Supplement #5 to
Morkrum Specs. 111 to 112,
Postal Spec. W. S. 5.
September 1924.

MORKRUM MULTIPLEX PRINTING TELEGRAPH SYSTEM

This supplement forms a part of Morkrum Specifications #111 and #112 and Postal W.S. 5, dated January 1923, and covers changes in the Multiplex Correction Circuit, and Forks.

CHANGE IN CORRECTOR CIRCUIT WIRING.

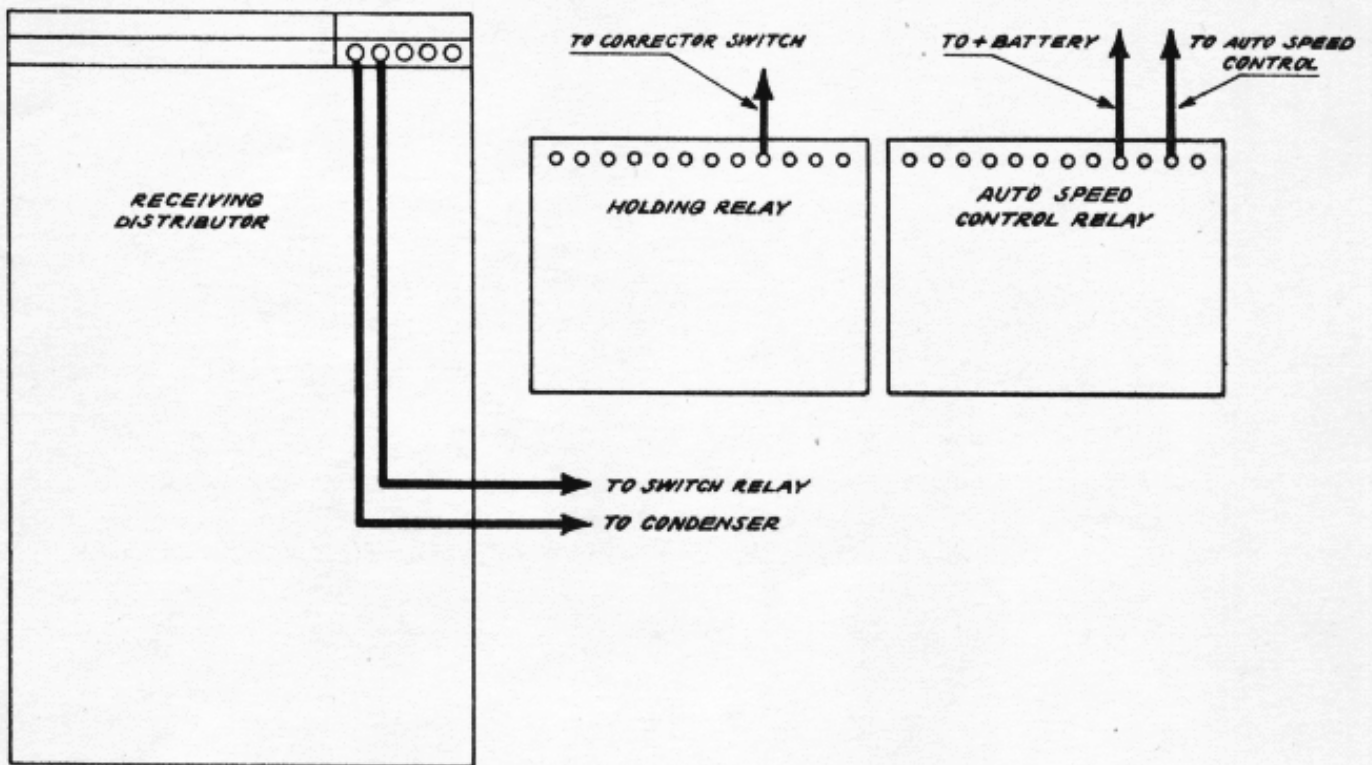
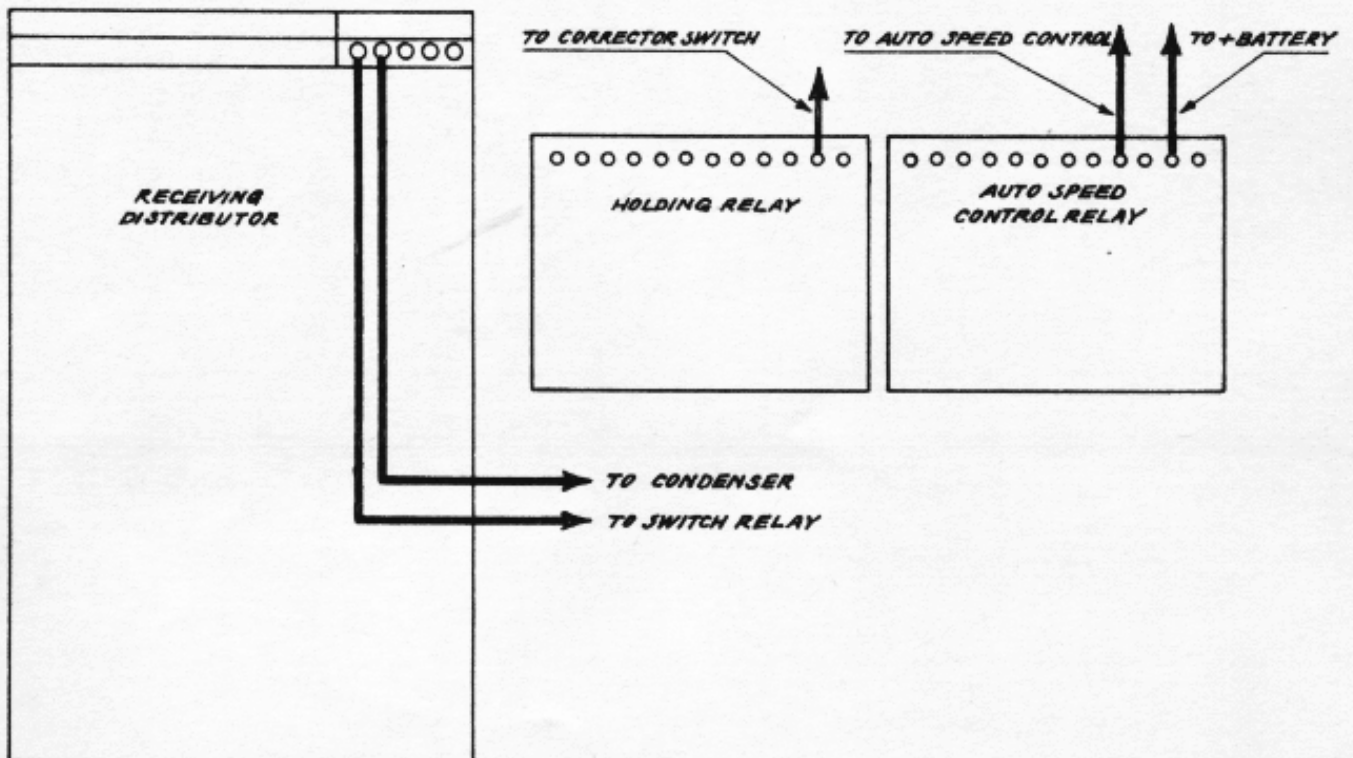
It has been found that by making a slight change in the wiring of the Multiplex correction circuit, that a more regular and stable correction is secured.

Referring to figure 7 of the Multiplex specification, it is to be noted that the switch relay is now connected to the #1 correcting segment and the condenser to the #2 segment, and that the reversals take place on the #2 or condenser segments. It has been found that if the reversal takes place close to the edge of the #2 segment, that the condenser does not get quite enough current to properly charge it, and at times this current is insufficient to properly operate the corrector relay.

The switch relay is more sensitive to short durations of current than is the condenser, so the circuit has been changed, placing the condenser on the #1 segment and the switch relay on the #2 segment. In this case, the switch relay is sensitive enough to be properly operated, even when the reversal occurs on the

very edge of the segment. This change effects the following connection shown on the attached sketch.

1. The wires going to the upper fourth and fifth terminals from the right on the receiving distributor clips are interchanged. This will interchange the condenser and switch relay connections.
2. The wire from the marking, or right-hand contact of the holding relay is moved to the left-hand or spacing contact. That is, the wire going from the fourth terminal from the right of the holding relay clip on the table is moved to the second clip from the right.
3. The wires going to the second and fourth clip from the right on the auto-speed control relay are interchanged. This will bring the range back to the center of the scale.

ORIGINAL WIRING.

WIRING AS CHANGED.

MORCRUM CO.
572
 DEC. 3, 1923
 WIRING DIAGRAM
MDT5
 (100)
MDT8
 TABLE

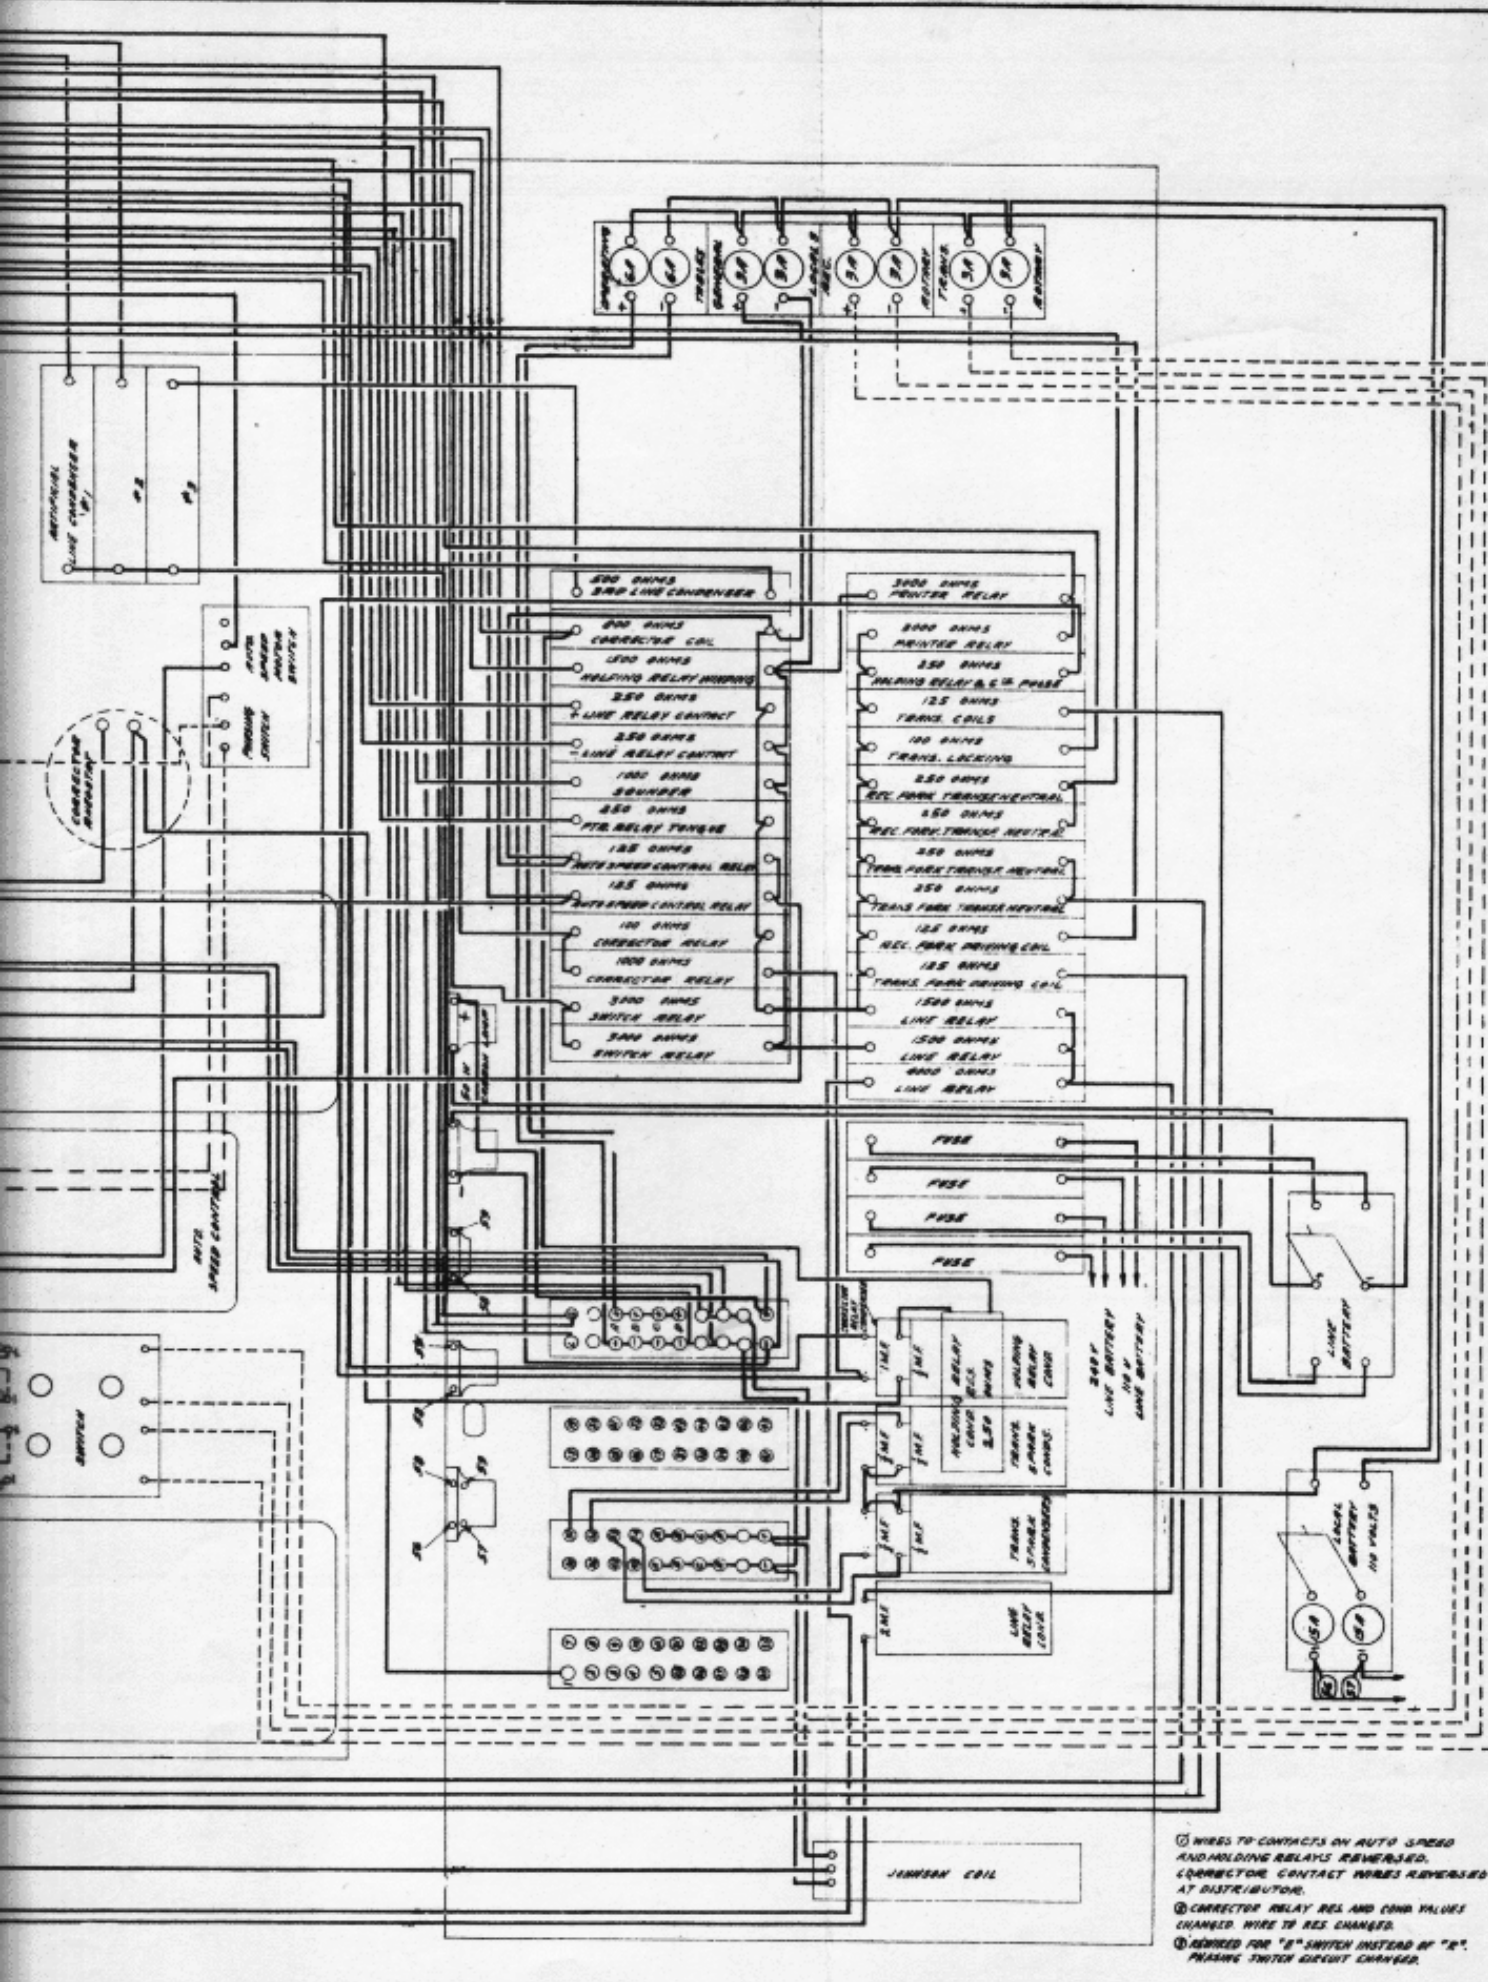
The various changes have been incorporated in the attached wiring diagram of the distributor table.

① WIRES TO CONTACTS ON AUTO SPEED AND HOLDING RELAYS REVERSED. CORRECTOR CONTACT WIRES REVERSED AT DISTRIBUTOR.
 ② CORRECTOR RELAY REL AND COIL VALUES CHANGED. WIRE TO RES CHANGED.
 ③ REVISED FOR "B" SWITCH INSTEAD OF "R". PHASING SWITCH CIRCUIT CHANGED.

WIRING DIAGRAM
FOR FORK

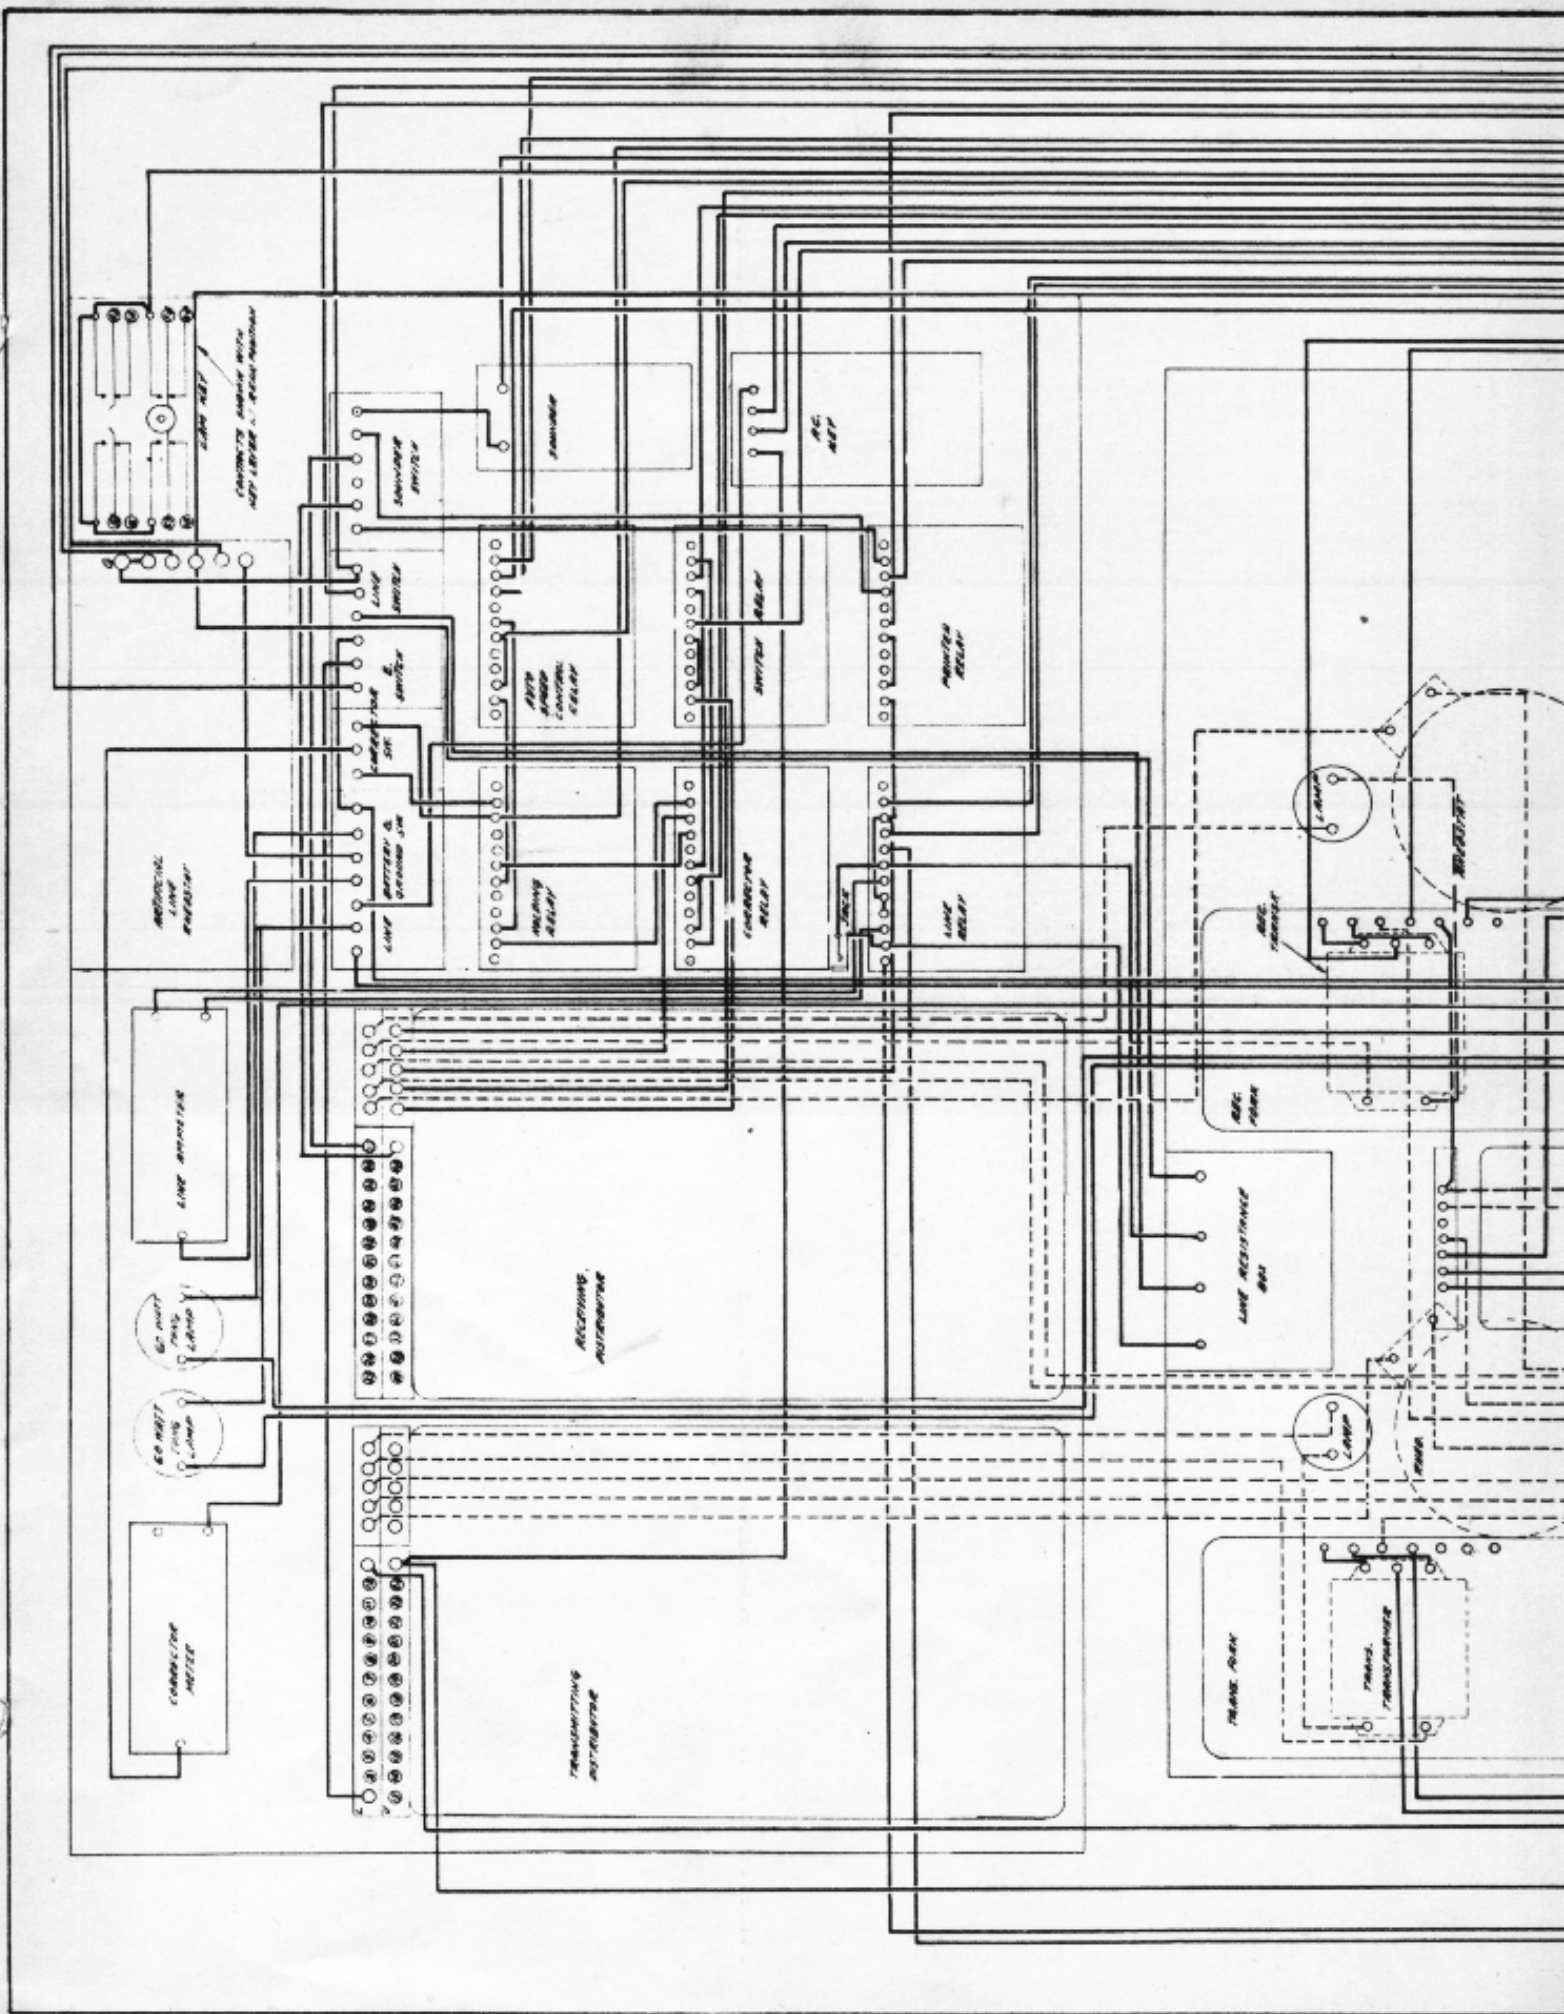
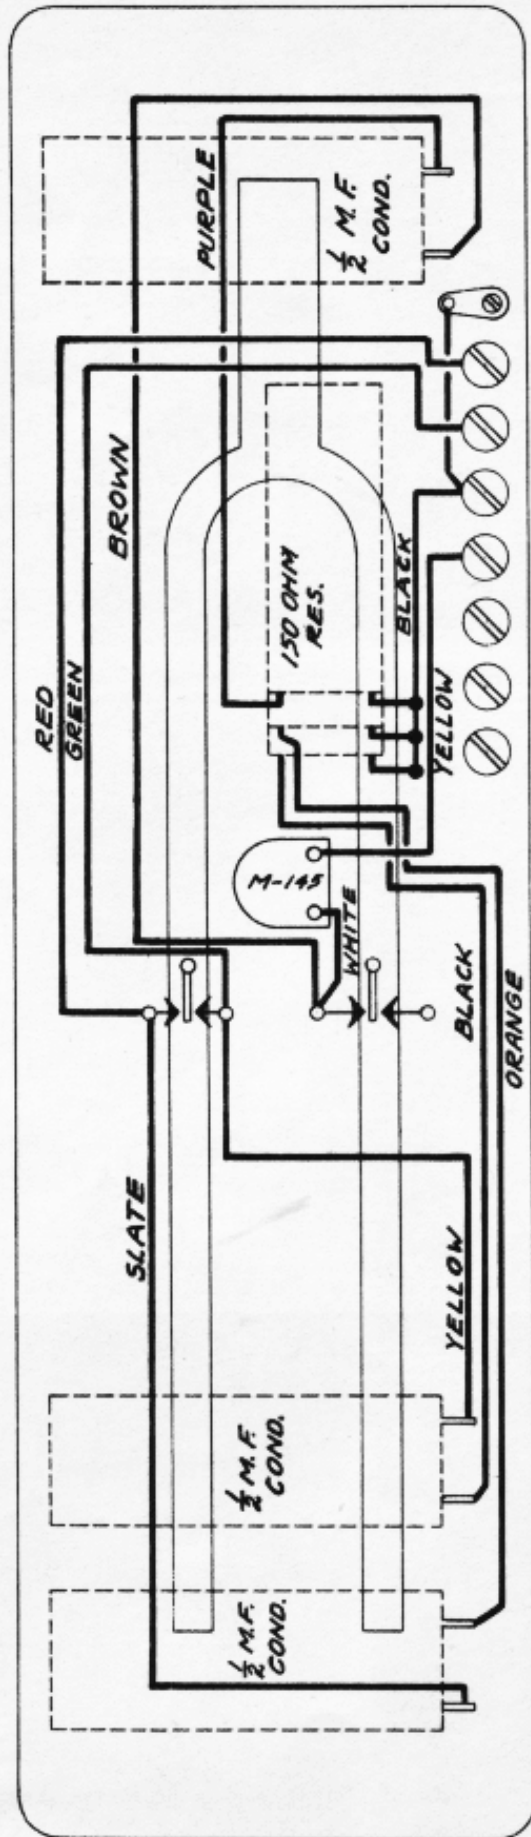
The transmitting and receiving forks have been slightly changed in design to make them adaptable to other than Multiplex purposes. The change on the forks is the addition of the seventh terminal placed in front of the six previously used.

On the transmitting fork, this terminal is not used, so that the fork is substantially the same as it previously was with the exception of the mechanical addition of the terminal.

Wiring diagram #604 superseding #417 shows the new transmitting fork. The wiring of the two forks is exactly the same as it is to be noted that the only change is the addition of the front terminal.

WIRING DIAGRAM
 RF 3 RF 4
 RF 6 FORKS

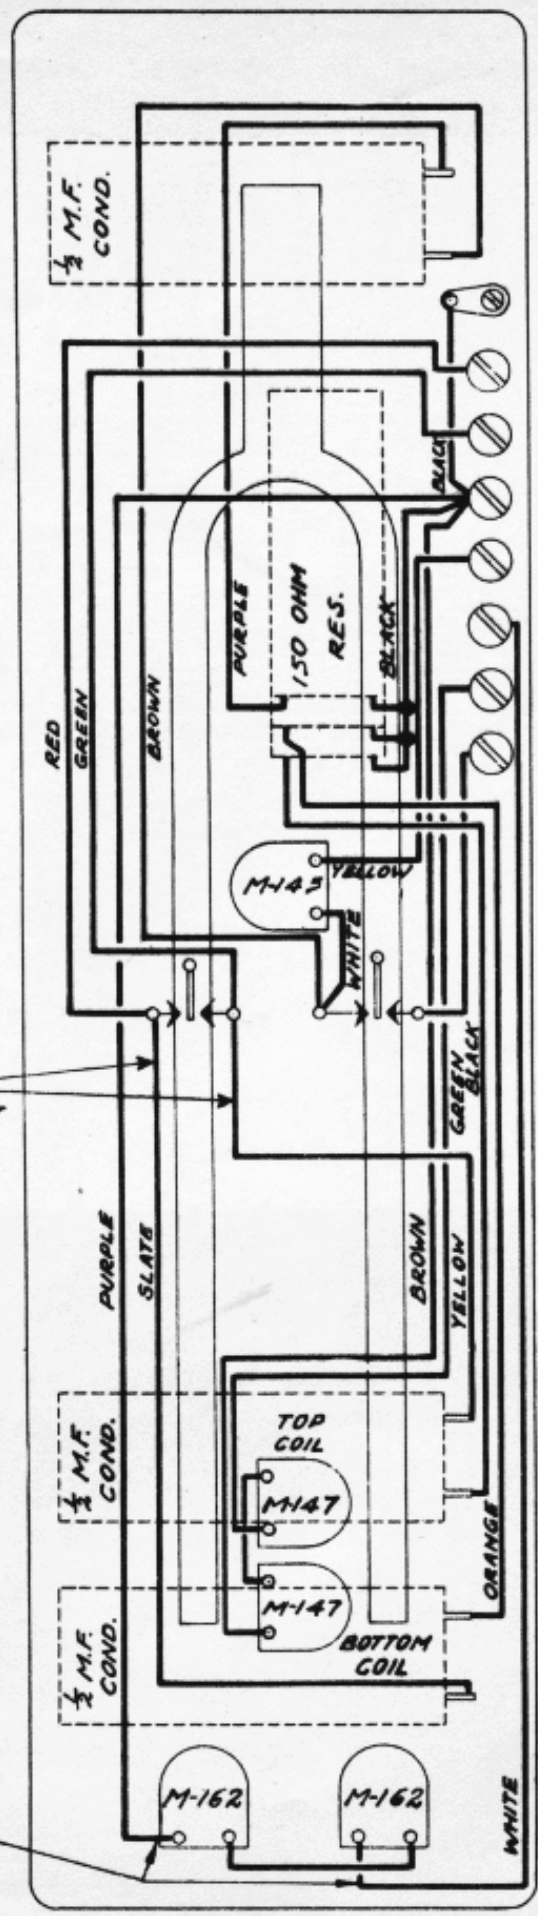
The receiving fork is shown in the wiring diagram #605 which supersedes wiring diagram #495 in the original specification. It is to be noted that in this case that the extreme right-hand contact is connected to the added seventh terminal. Otherwise, the new receiving fork is identical with the old one.

- ① JUMPER ON M-MT COILS CHANGED A.S.B. JULY 7, 1926
- ② RF 6 ADDED MARCH 13, 29 REA
